The Commission has issued the enclosed Amendment No. 52 to Facility Operating License No. DPR-57 for the Edwin I. Hatch Nuclear Plant Unit No. 1. The amendment consists of changes to the Technical Specifications in response to your request of August 26, 1977 as supplemented December 1, 1977, January 5, February 22 and March 8 and 16, 1978.

The amendment modifies the Technical Specifications to: (1) permit operation of the facility during Cycle 3 with up to 168 improved two water rod 8x8R reload fuel bundles, designed and fabricated by the General Electric Company (GE) and having an average enrichment of 2.65 wt/% U-235, and (2) revise the maximum average planar linear heat generation rates (MAPLHGR's) as determined by the reevaluation of the ECCS performance.

EDWIN I. HATCH NUCLEAR PLANT UNIT NO. 1

EDWIN I. HATCH NUCLEAR PLANT UNIT NO. 1  
RELOAD 2  
SAFETY EVALUATION REPORT

FIGURE 3.11-1 (SHEET 1)

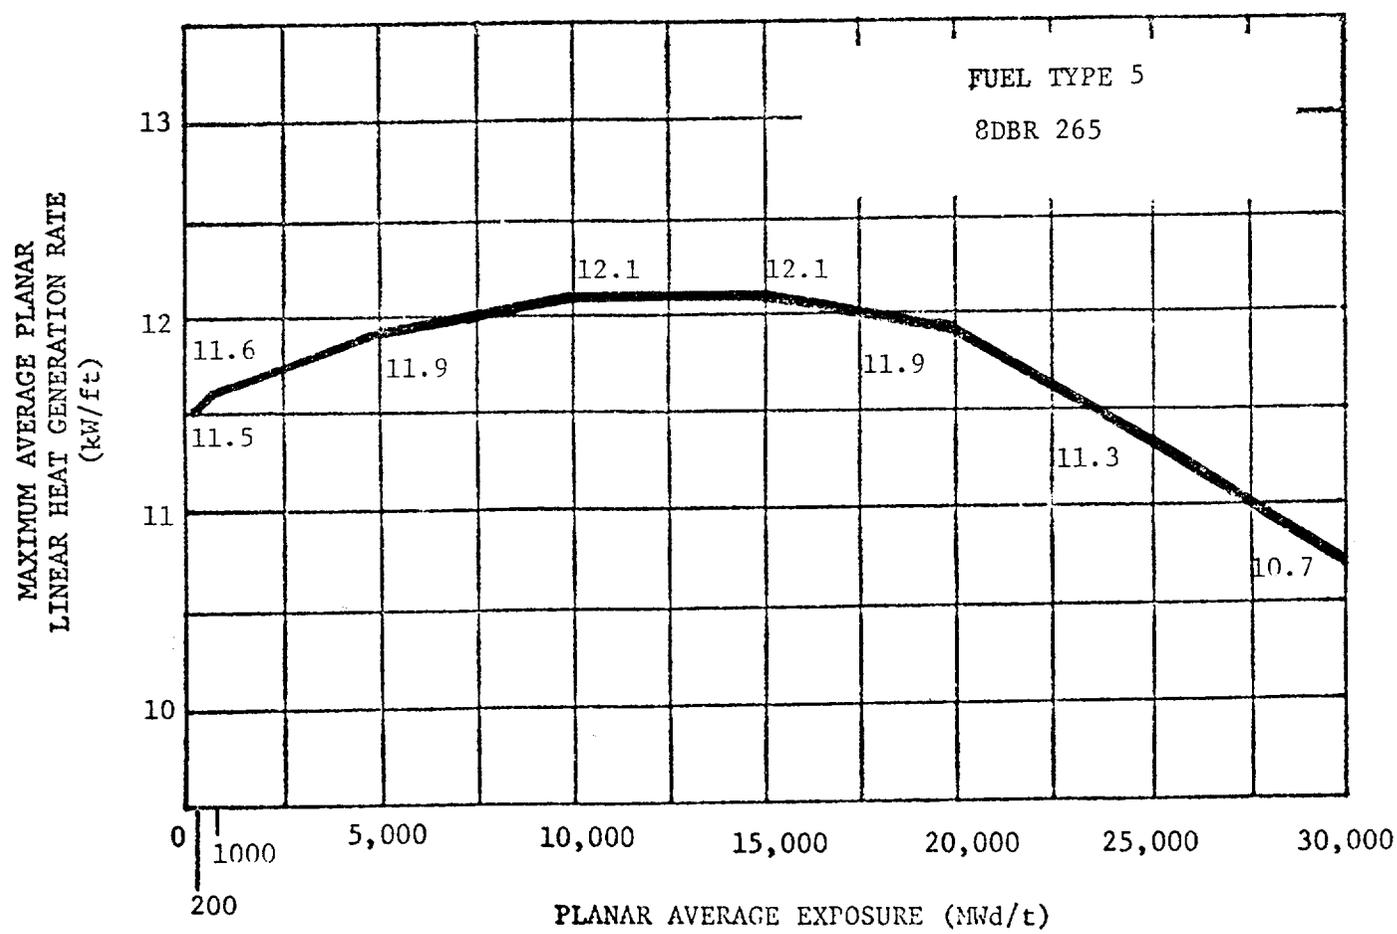
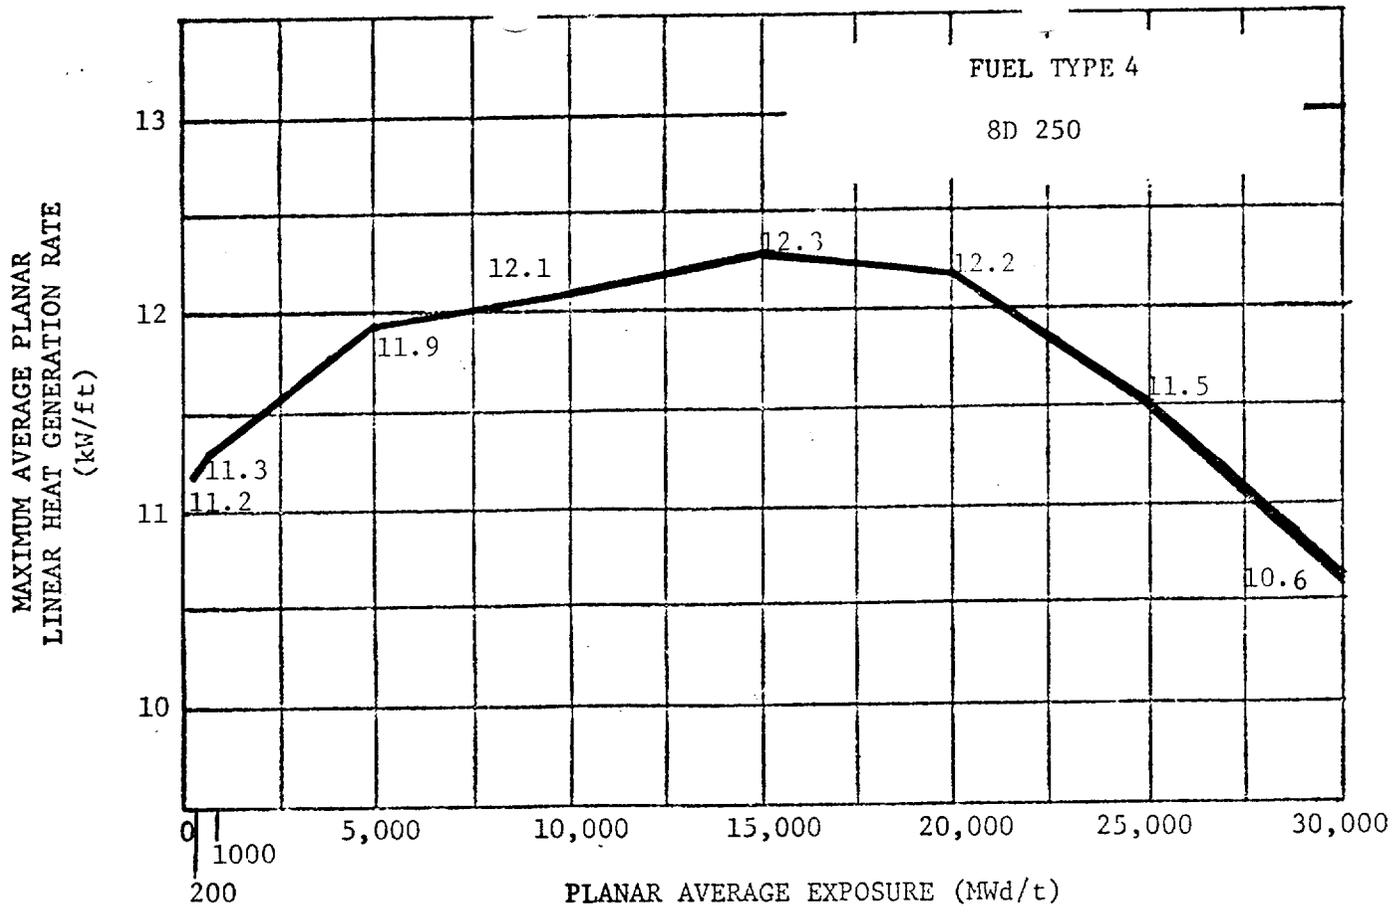
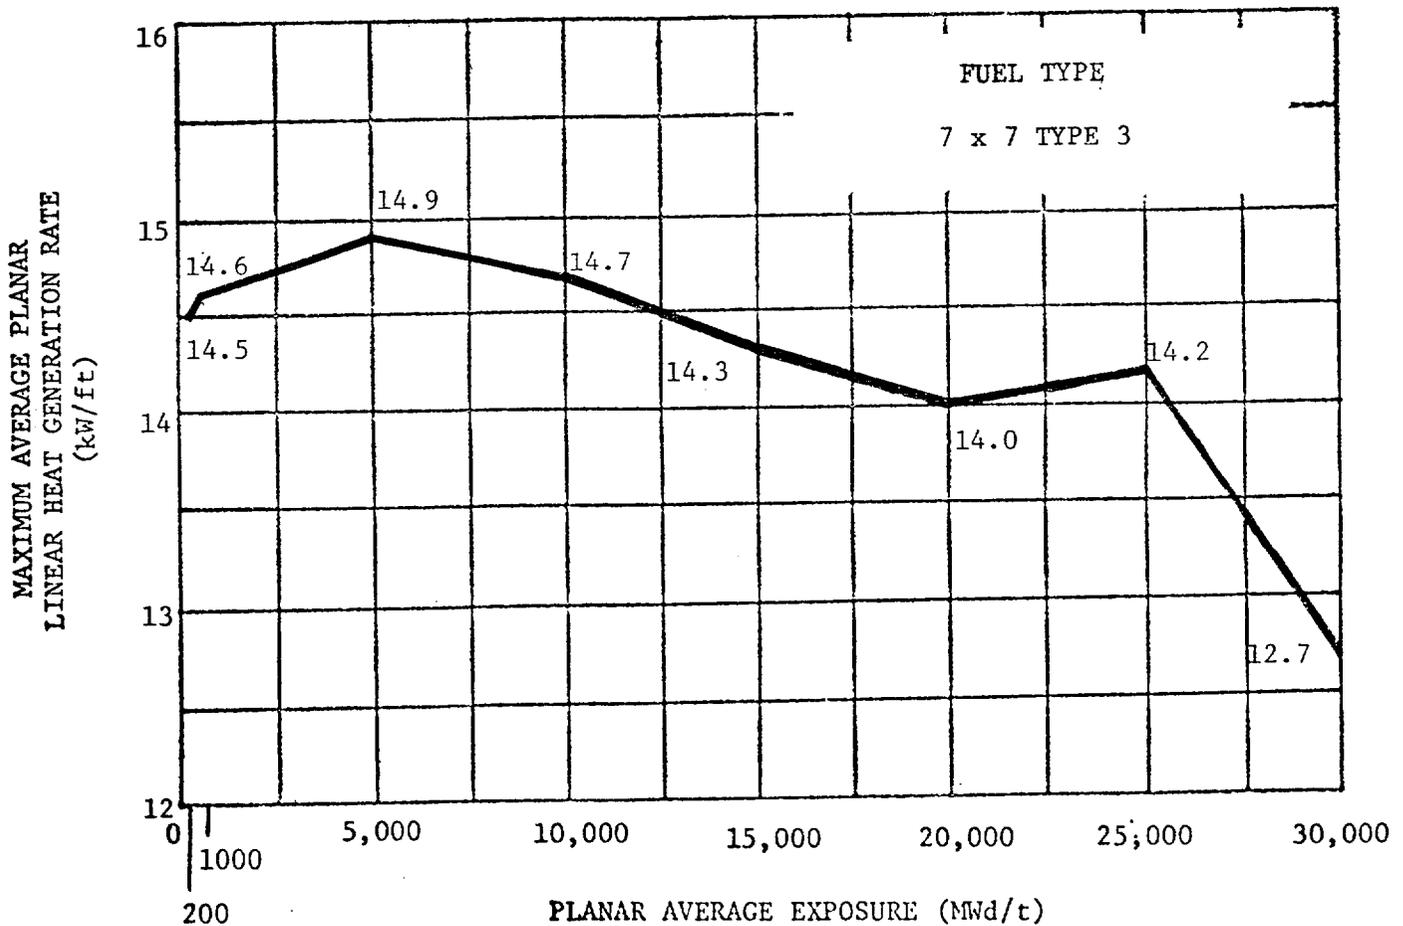
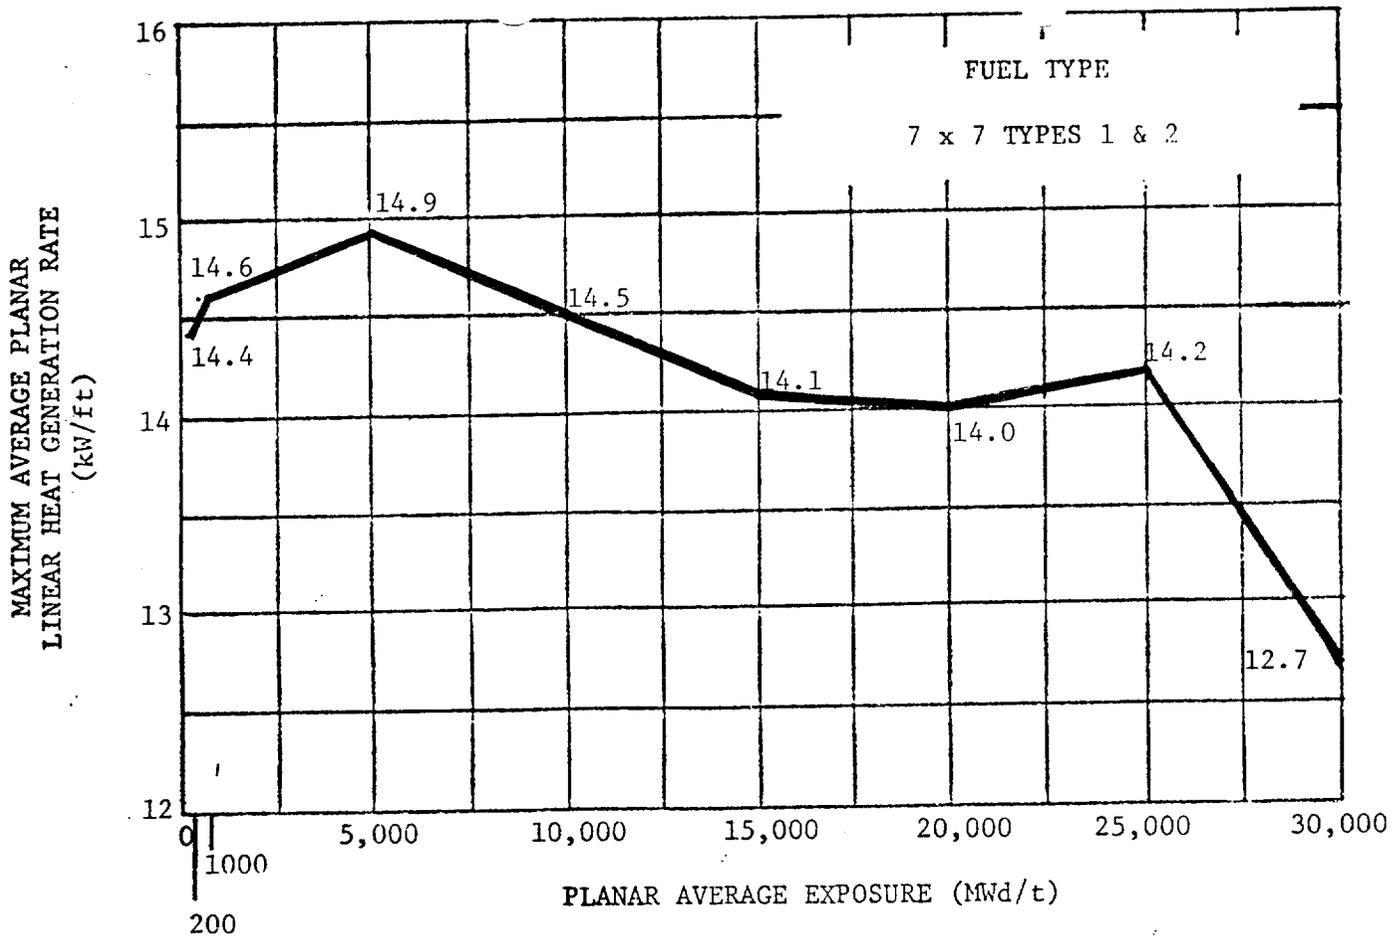
During power operation, the APLHGR for each type of fuel as a function of average planar exposure shall not exceed the limiting value shown in Figure 3.11-1, sheets 1 and 2. If at any time during operation it is determined by normal surveillance that the limiting value for APLHGR is being exceeded, action shall be initiated within 15 minutes to restore operation to within the prescribed limits. If the APLHGR is not returned to within the prescribed limits within two (2) hours, then reduce reactor power to less than 25% of rated thermal power within the next four (4) hours. If the limiting condition for operation is restored prior to expiration of the specified time interval, then further progression to less than 25% of rated thermal power is not required.

The licensee has also proposed changes and additions<sup>(5)</sup> to the MAPLHGR vs. planar average exposure curves currently appearing in the Hatch-1 Technical Specifications. Our evaluation of the proposed curves is discussed in Section 3.5.1. The MAPLHGR changes for the 7x7 and standard 8x8 fuel types reflect the results of revised LOCA calculations, performed to correct all of the GE input errors, made in connection with the previous LOCA analysis. An additional MAPLHGR curve, based on corrected inputs for the reload 8x8R fuel is also provided. Based on our evaluation of the information provided, the staff finds the proposed new MAPLHGR vs. planar average exposure curves appearing in Figure 3.11-1 of Reference 4 to be acceptable.

Thus, based on our review of the applicability of the ECCS-LOCA models to the 8x8R fuel type, the corrected analyses<sup>(4)</sup> and the lead plant analysis, we conclude that Hatch-1 will be in conformance with all requirements of 10 CFR 50.46 and Appendix K to 10 CFR 50.46 when operated in accordance with the MAPLHGR versus Planar Average Exposure curves given in Figure 3.11-1, sheets 1 and 2, of the proposed Technical Specifications<sup>(5)</sup>.
